**RV Kits**

**Models:** Paramounts built prior to September 1, 2008.  
**Purpose:** To prevent the awning from over extending causing the arm elbows to lock out.  
**Summary of Work:** For each arm: Remove existing spacer from elbow, add additional spacers.

Drill Out the Existing Rivet and Spacer

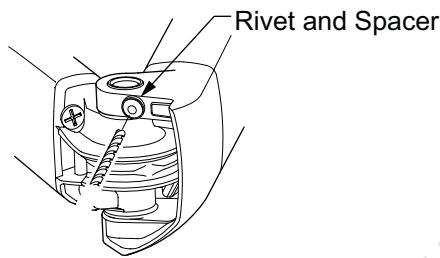
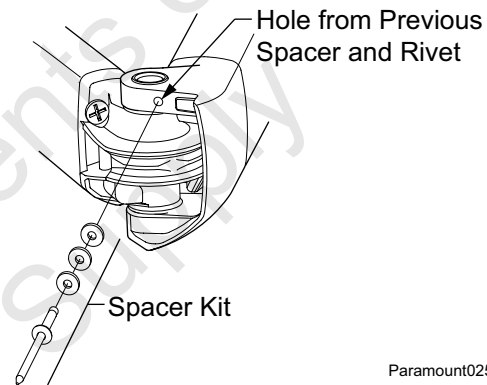
1. Open the awning 12"-14" past the slide out room position to provide access to the long arm elbows.
2. Using an 1/8" drill bit, drill out the existing rivet and spacer and discard.

3. In the existing hole, attach the three (3) spacers to the elbow using the furnished pop rivet.
4. Repeat for both arms.
